3. Description of Amendments

3.2 Overview of Proposed Amendments

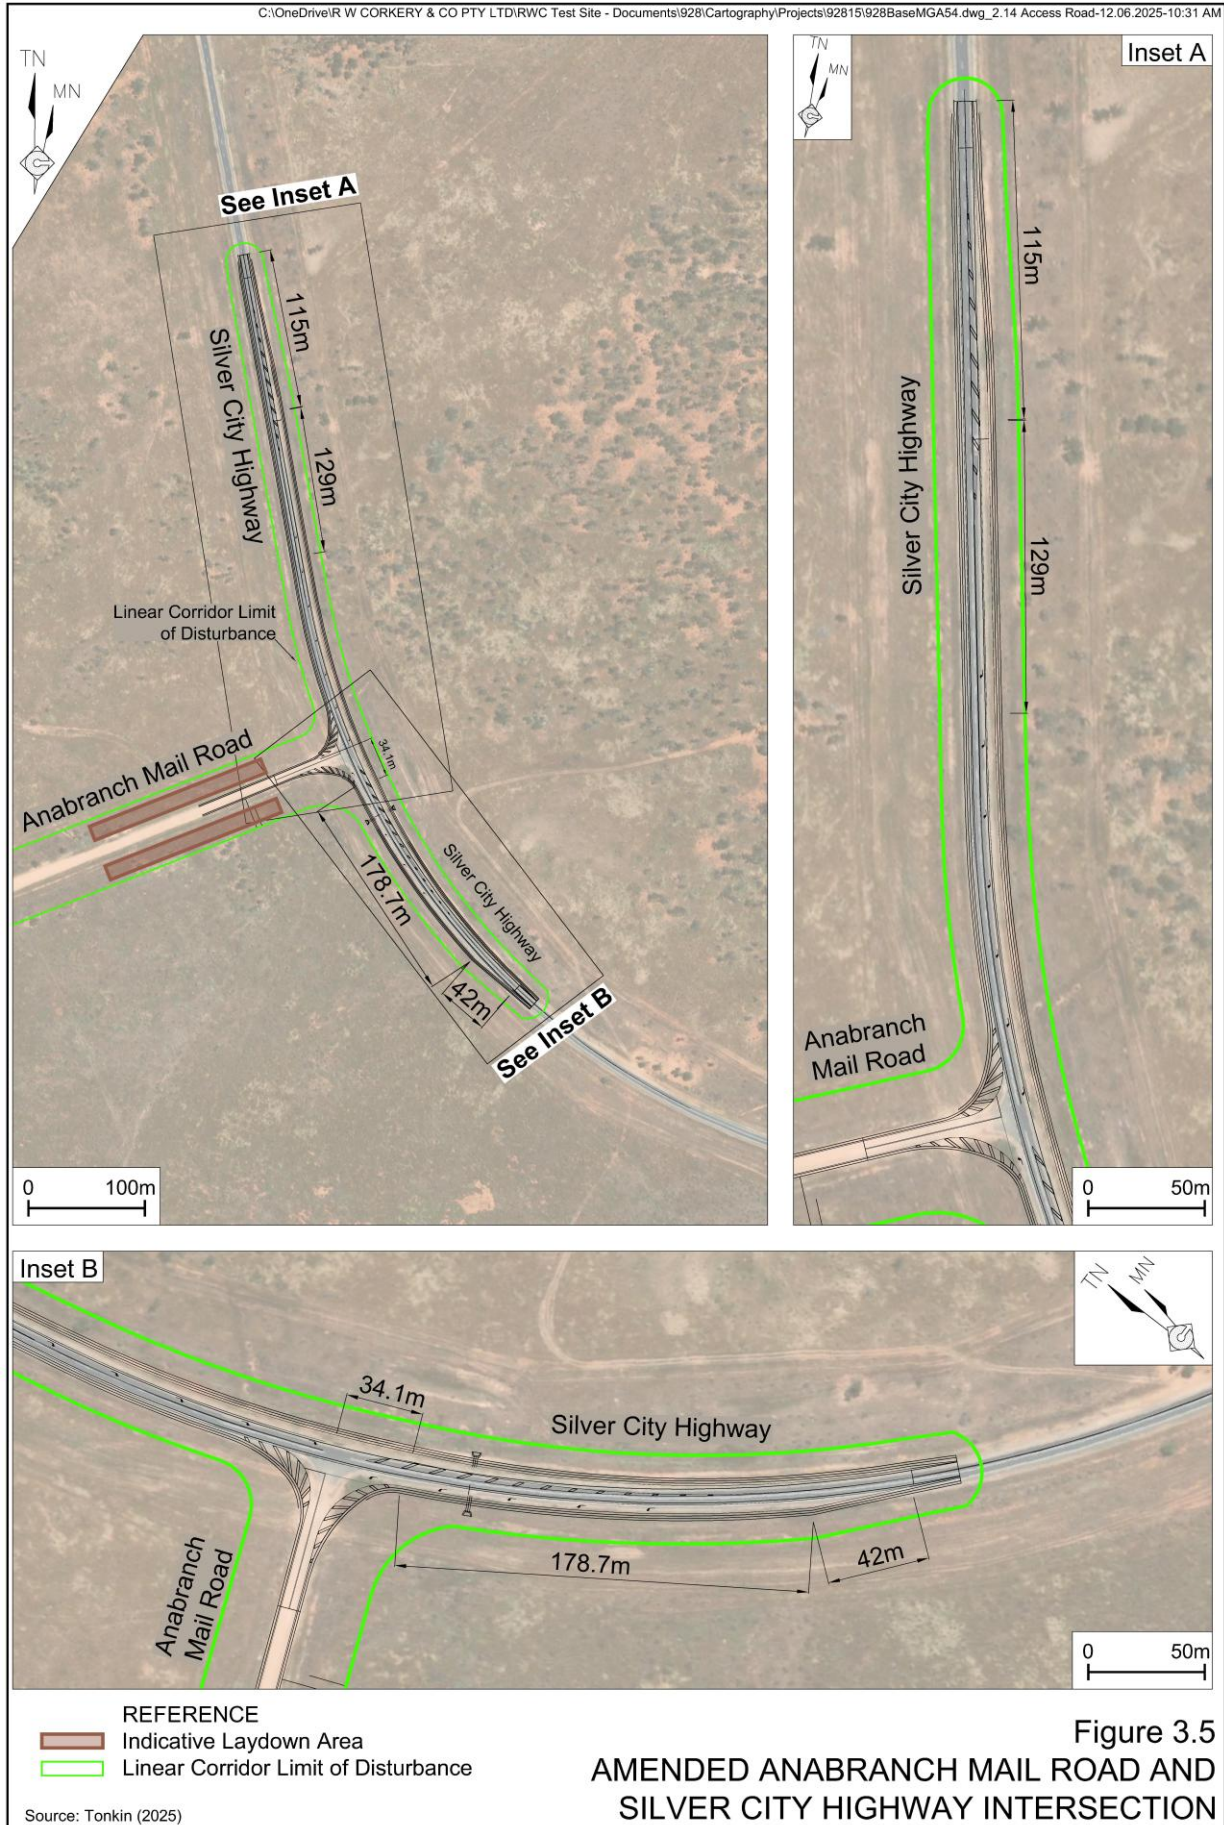
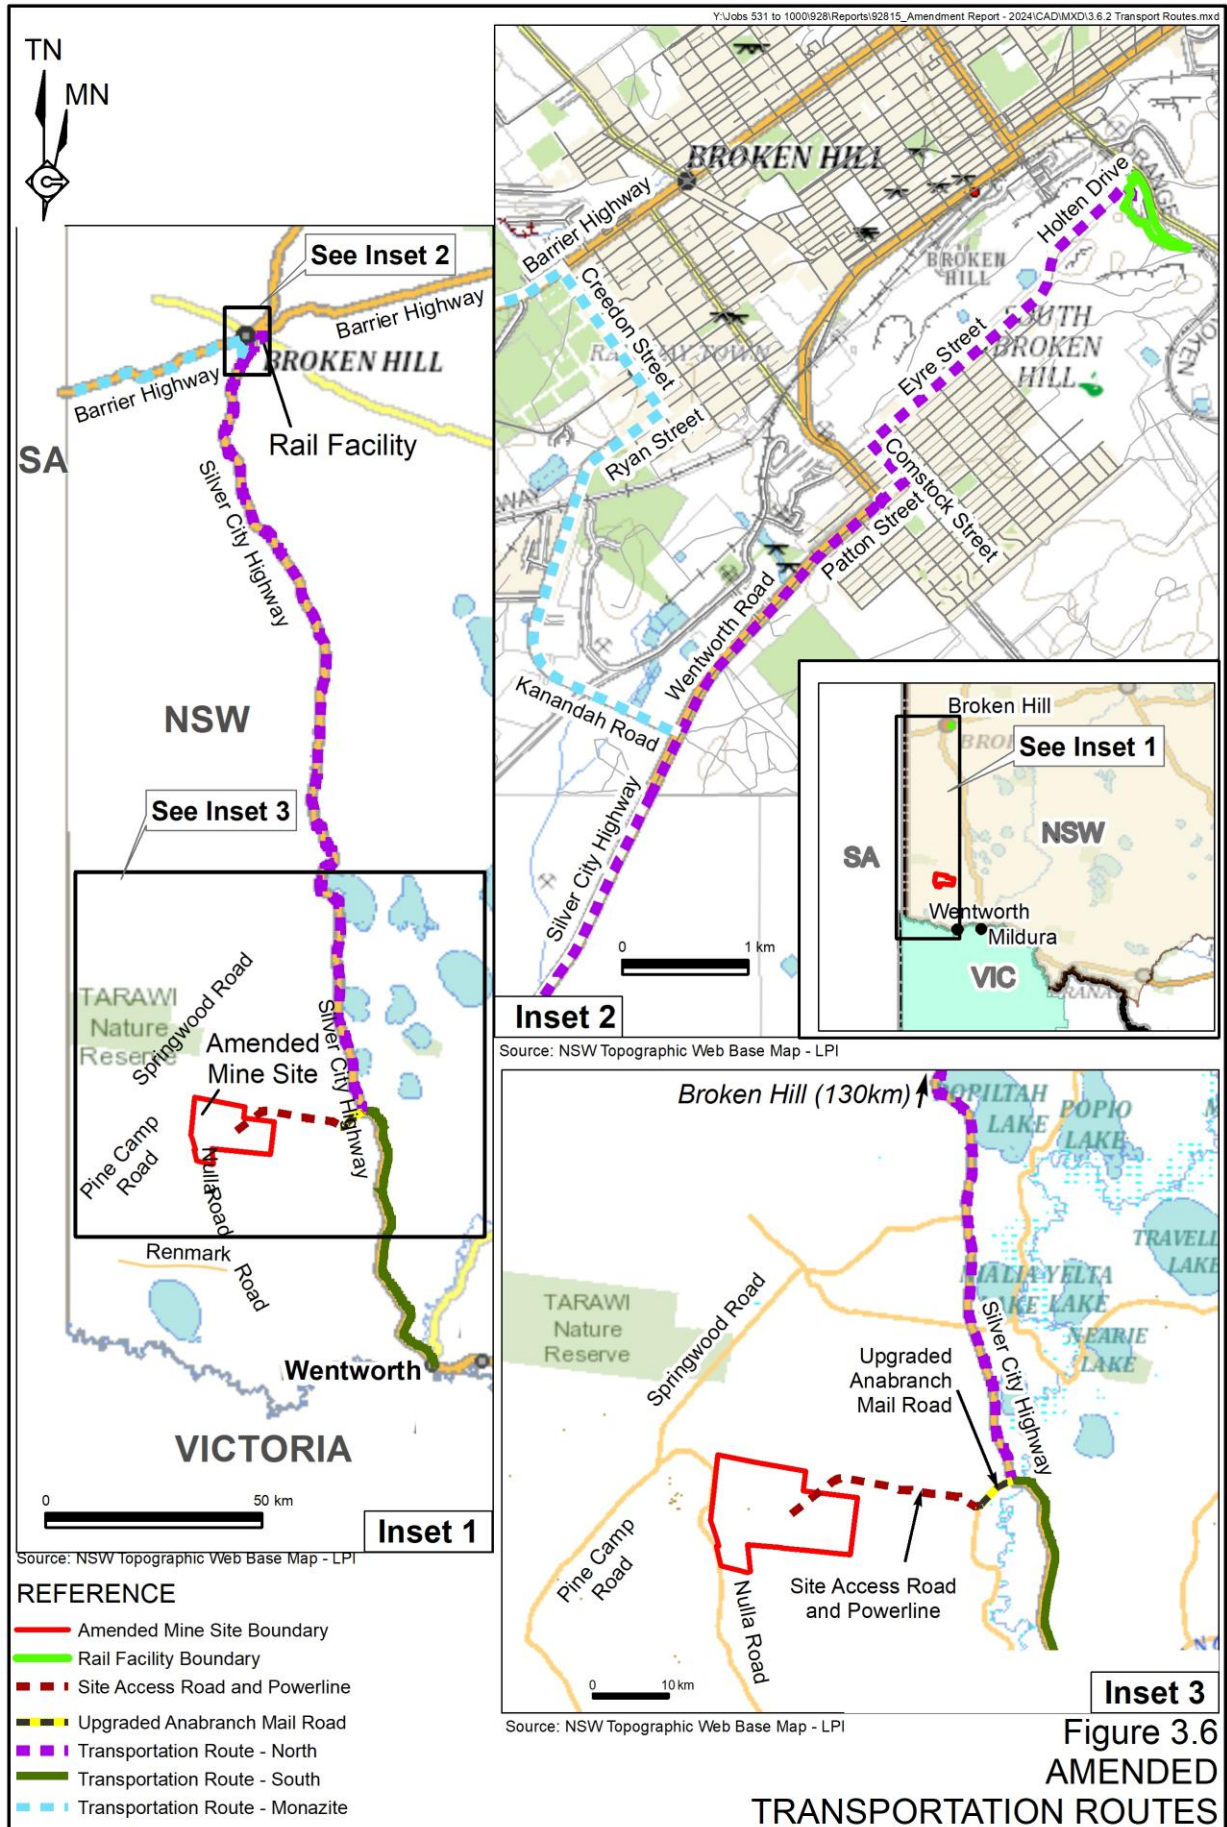
For the avoidance of doubt, the Applicant proposes that up to 7,500tpa of Monazite Product would be transported via road from the Mine Site to port in South Australia via Broken Hill. The Monazite Product would be transported via Transportation Route – North to the intersection of the Silver City Highway and Kanandah Road on the western outskirts of Broken Hill (**Figure 3.6**). From there the Monazite Product would be transported using an approved heavy vehicle route via Kanandah Road, Ryan Street, Creedon Street and the Barrier Highway to the South Australian border (Transportation Route – Monazite). Vehicles returning from the South Australian border would travel via the same route.

Figure 3.7
AMENDED INDICATIVE FINAL
LANDFORM AND FINAL LAND USE DOMAINS

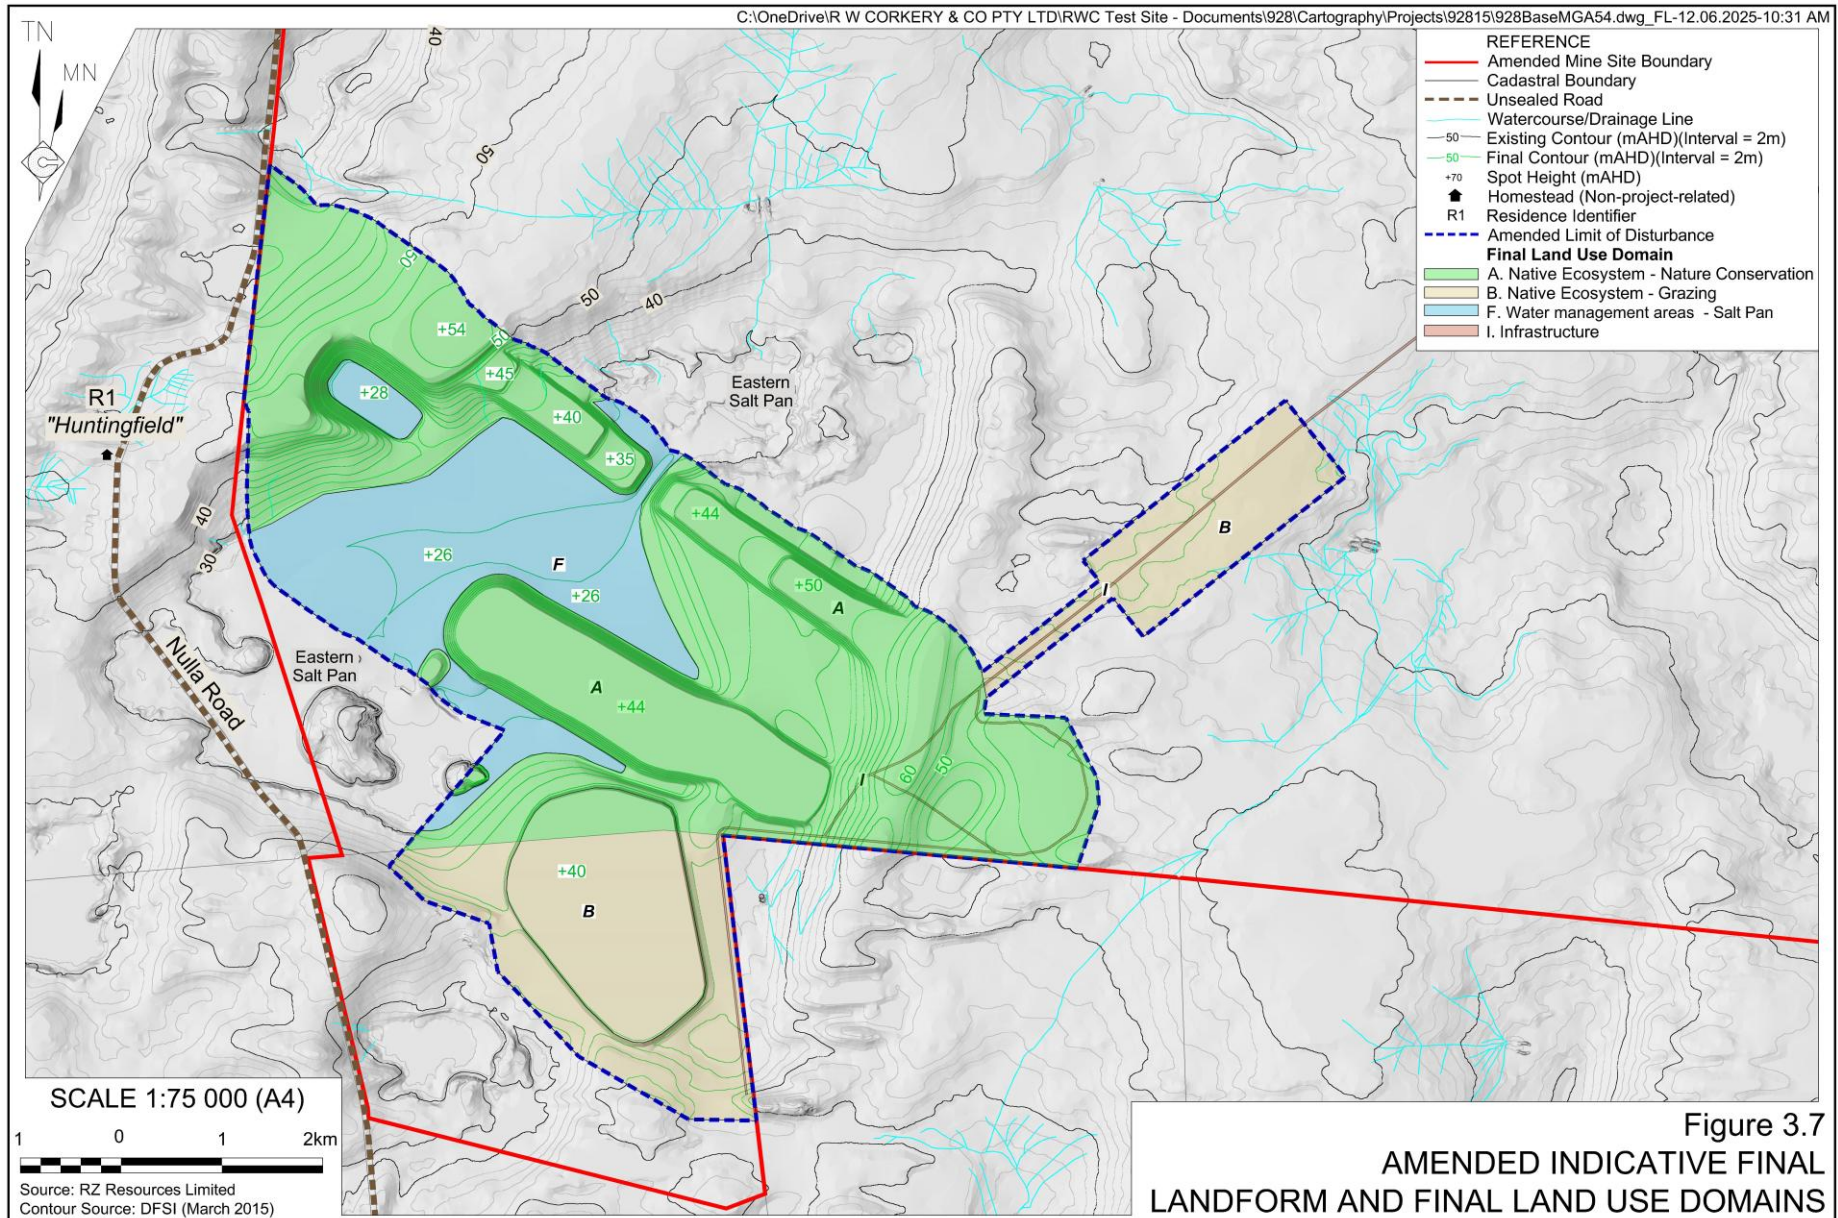
Figure 3.7 presents the amended final landform for the Project. In summary, the design criteria for the final landform would remain as described in Section 3.12.2.1 of the EIS as exhibited. However, the amended Extraction Area and material movement schedule would result in a final landform that varies from that presented in the EIS.

Figure 3.7 also presents the amended final land use domains for the Project would include the following.

Finally, as Nulla Road would no longer be disturbed, a realigned Nulla Road is no longer proposed for the final landform.
